Change Order No. 56

Contract Title: Rainier Ave S Corridor Improvements – Phase 4

Contract No.: CAG-22-163

This change replaces the requirement to grind and overlay sections of Rainier Ave. S from S 2nd St. to Airport Way (approximately STA 20+28 RT to STA 31+75 RT), and on S. Tobin St. (approximately STA 500+50 to 500+90) with the requirement to perform full depth pavement removal and replacement, which increases the flagging required from S 2nd St. to Airport Way.

RFI #522: Cut Beyond Demo Limits Tobin to Airport

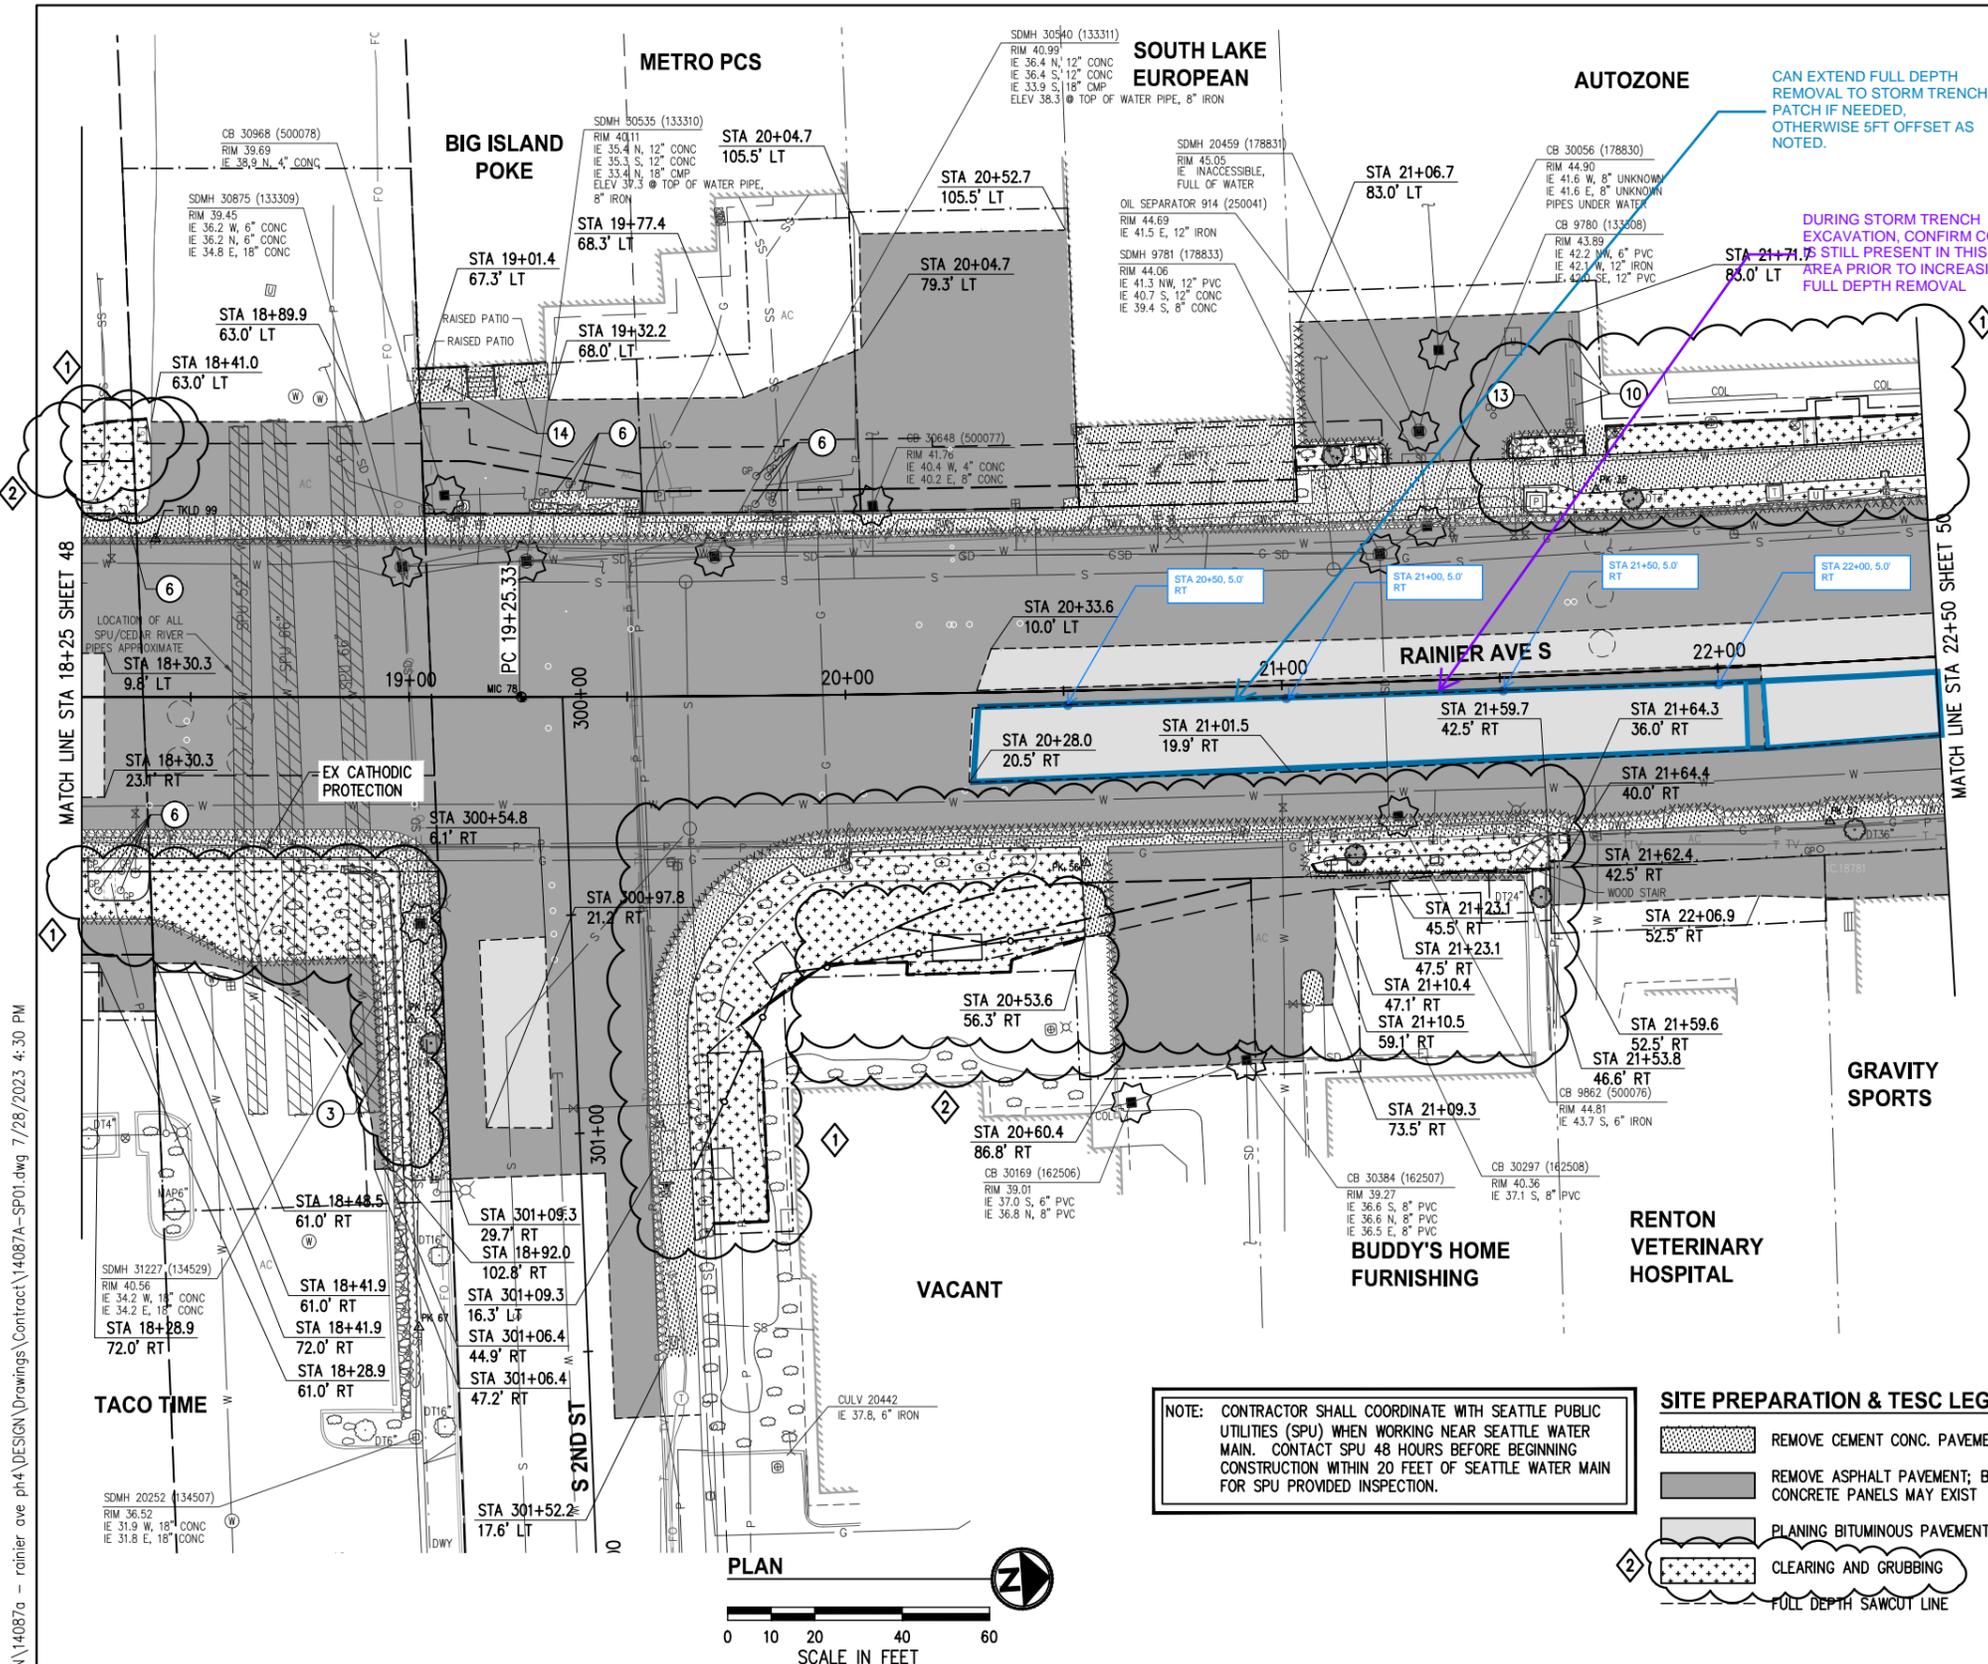
Sheet 10 states plane bituminous pavement 1.5" min depth to 4" max depth. Any planing over 4" is a change.

Please provide direction and revised paving plans that are constructible based on existing grades and roadway section.

Please see the attached revised full depth removal areas. A field directive will be prepared with revised plan sheets. Please provide a cost proposal for this added work which will be reviewed and incorporated into a future change order.

DRAWING NO. 62
 PROJECT NO. 14087A
 FED AID NO. STP(U)-1615(005)
 DATE: JULY 2022
 SHEET NO. 62 OF 285

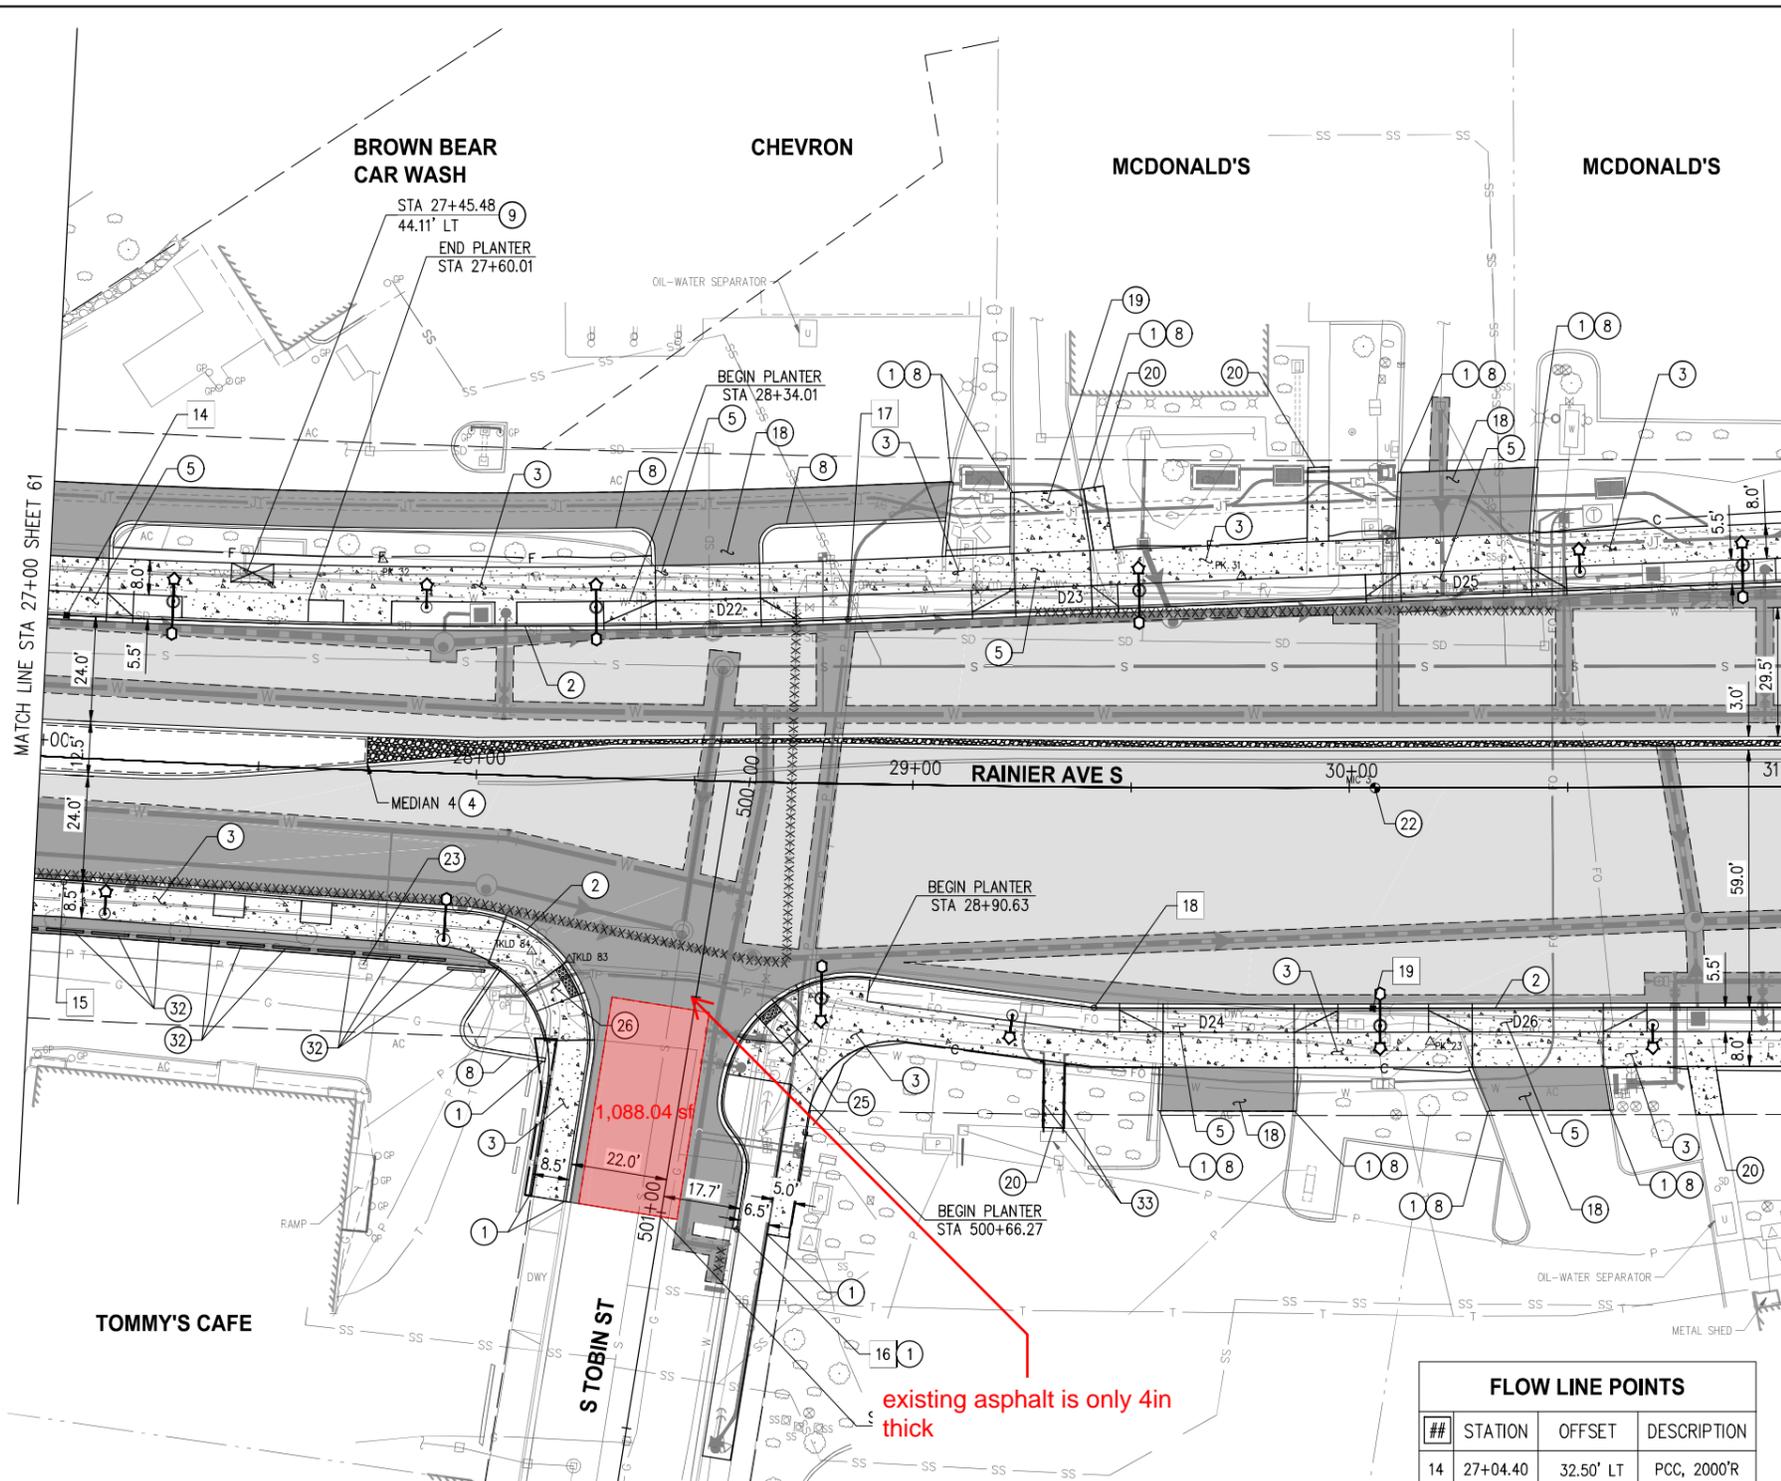
1. Roadway plan sheet 62 call to grind and overlay a middle portion of Tobin St. Pivetta discovered the existing asphalt is only 4in thick. A grind and overlay would results in minimal existing paving and suboptimal pavement thickness. Pivetta and Jordan Howe discussed and agreed to change grind and overlay area on Tobin to full demo and new asphalt section. This changes 1,088 square feet from grind and overlay to full demo. Please confirm this for project records. The added demo and grading is extra work Pivetta requests a change order for, please confirm this will be paid as change order work.

There is only 4in of existing pavement at Tobin. There are few spots where there is a cut or the grind and overlay would result in no asphalt left to overlay. It changes depending on where you are. I think Joe needs to come help direct additional removal.

Does Tobin need full 12in section or can it be less?

If we are grinding pavement that is existing 4in should we grind less? What is minimum overlay depth allowed here? At what point do we extend demo limits. If we have some basic guidance we should be able to come up with new limits.

1. As discussed please perform full depth removal where the plans call for planing on Tobin due to the existing pavement condition being too thin to plane. The additional work to perform full depth removal will be addressed as part of a future change order.

2. As confirmed by KPG the new asphalt pavement on Tobin can be installed as 6" of PG 70-22 HMA over 4" of CSBC. This will be addressed as part of a future change order.

DRAWING NO. 63
 PROJECT NO. 14087A
 FED AID NO. STP(LUL)-1615(005)
 DATE: JULY 2022
 SHEET NO. 63 OF 285

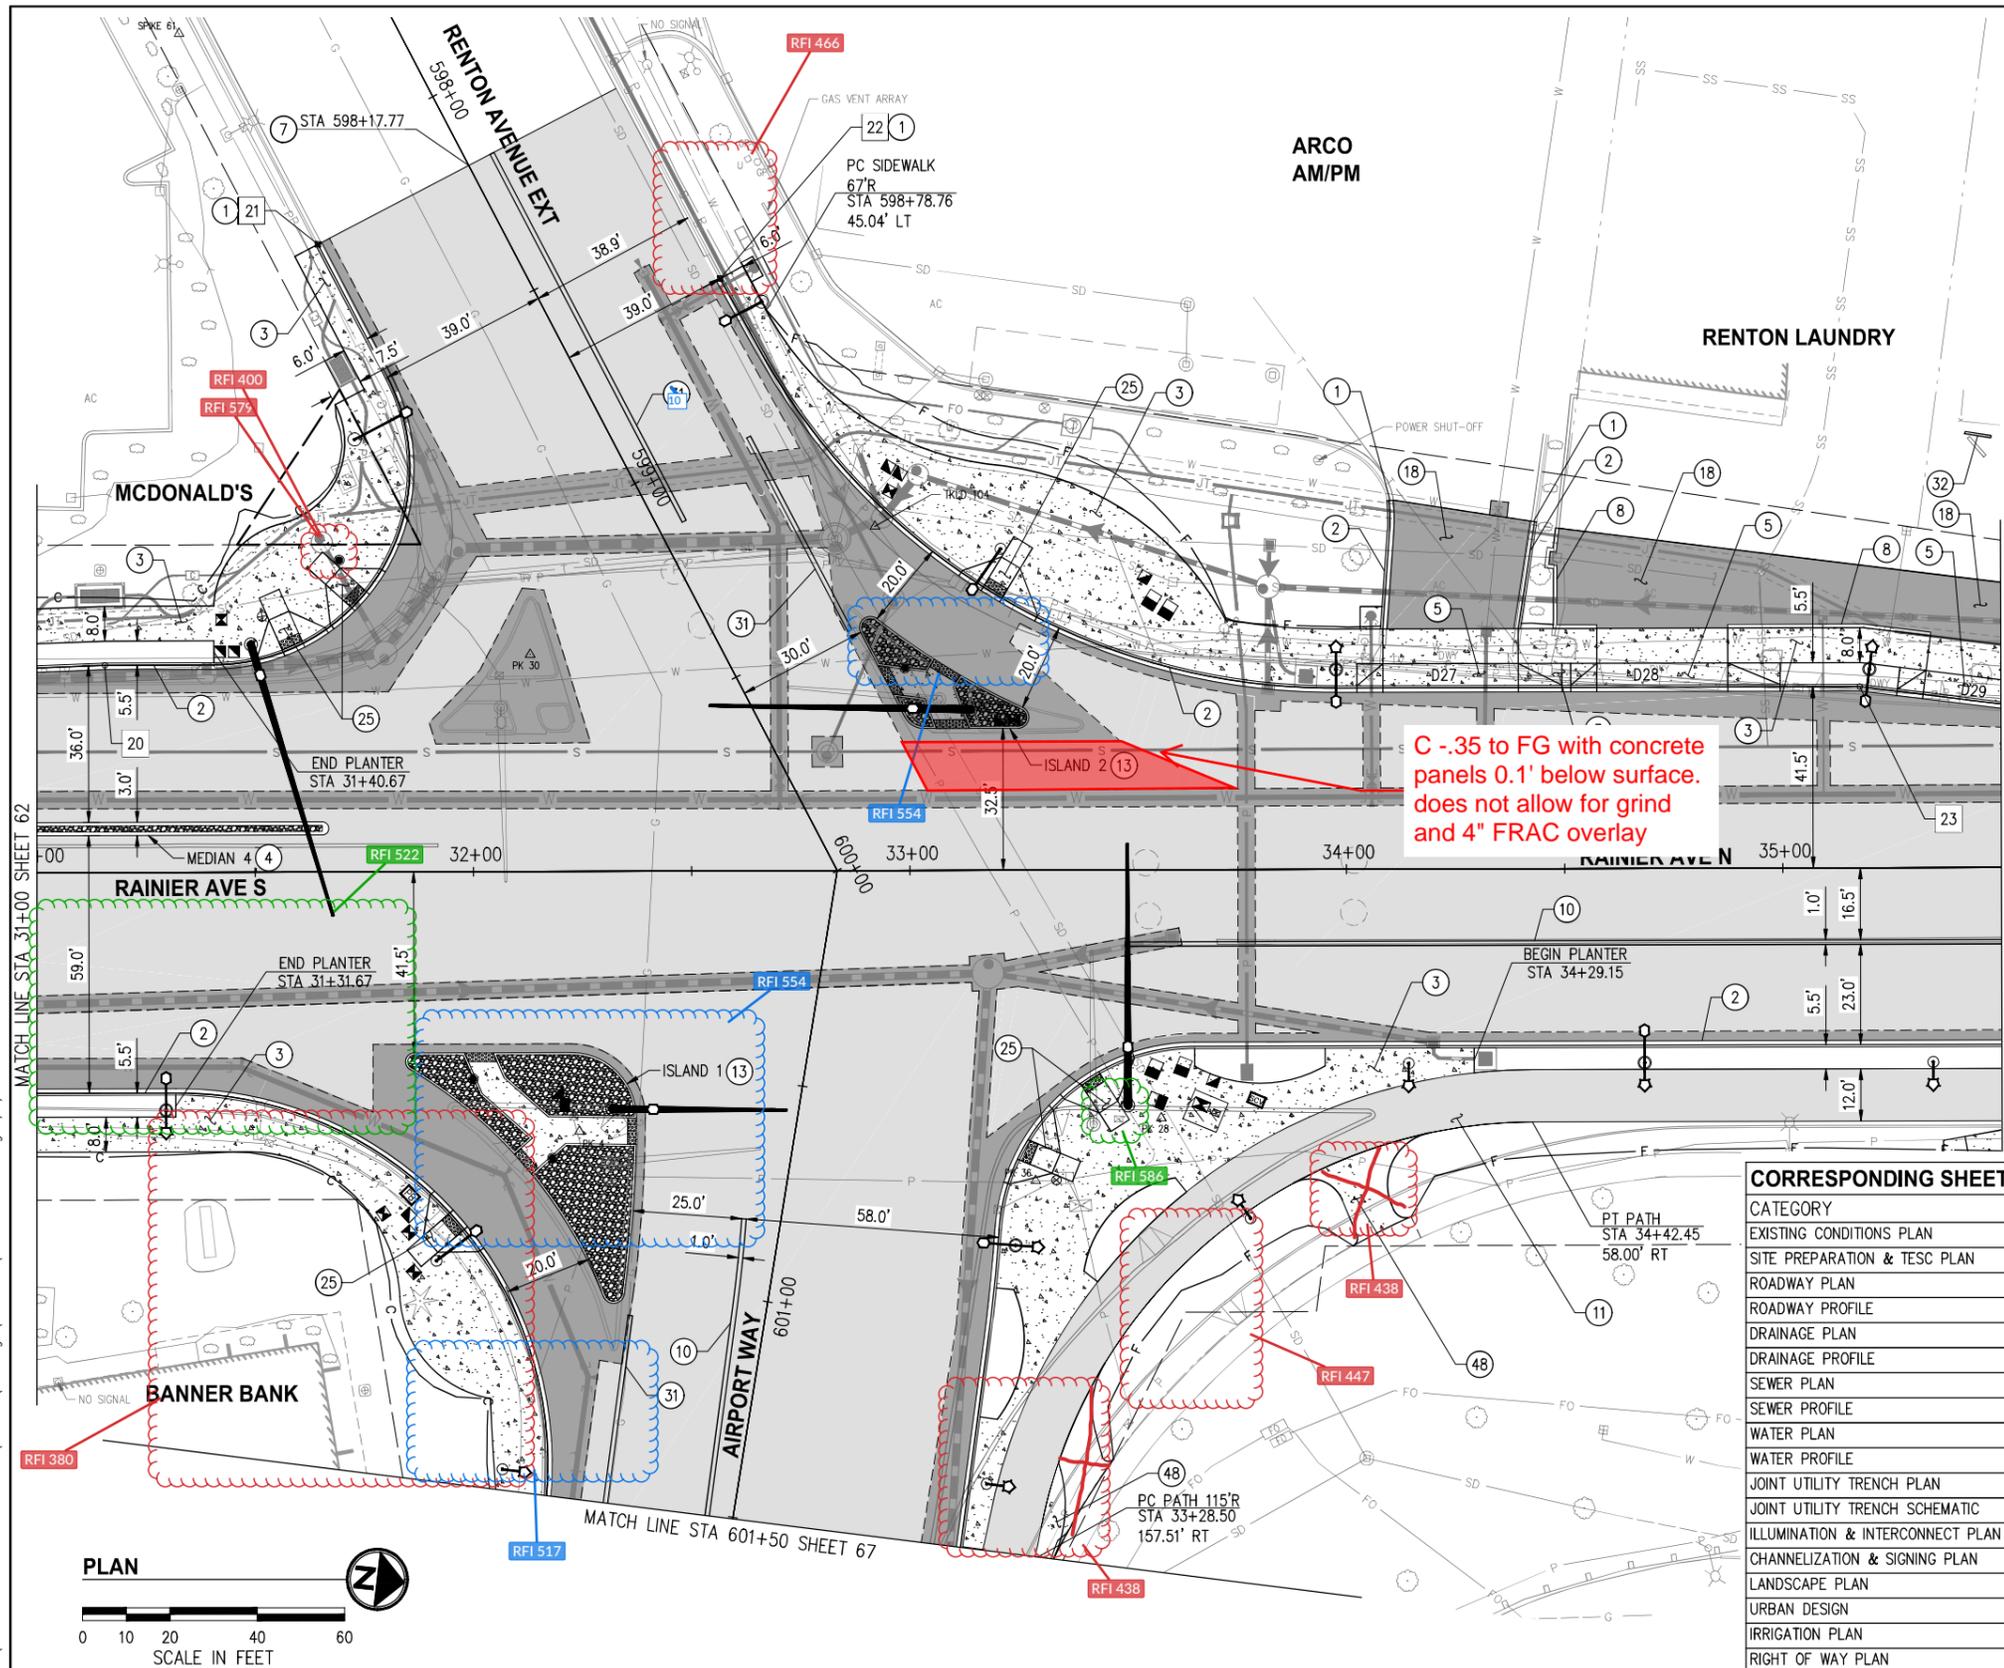
Pivetta observed an area just east of the Airport NW island that is a C-0.35' to FG with concrete panels about 0.1' below halt surface. It will not be possible to grind and get any FRAC overlay. This was reviewed in the field with Jordan Howe on 9/11/25. Pivetta recommends added full depth asphalt replacement from the watermain t-cut to the island as shown in the attachment.

Please confirm added demo as shown/confirmed in the field is acceptable.
Please confirm added sawcutting/demo/grading will be tracked and paid as force account change order and the CSBC and HMA placement will be tracked as bid item.

As confirmed in the field the pavement section between the island and the water main trench T cut area shall be removed and replaced with full depth HMA to resolve the conflict between the existing concrete panels which were under the ground out asphalt and finished grade (these panels in this area were higher than finished grade). This work will be tracked by force account and paid as part of the future change order related to added pavement removal. The new asphalt shall be installed so that there is enough room for a 4" overlay over the pavement section. The installation of the CSBC and HMA will be paid as part of the CSBC and HMA bid items.
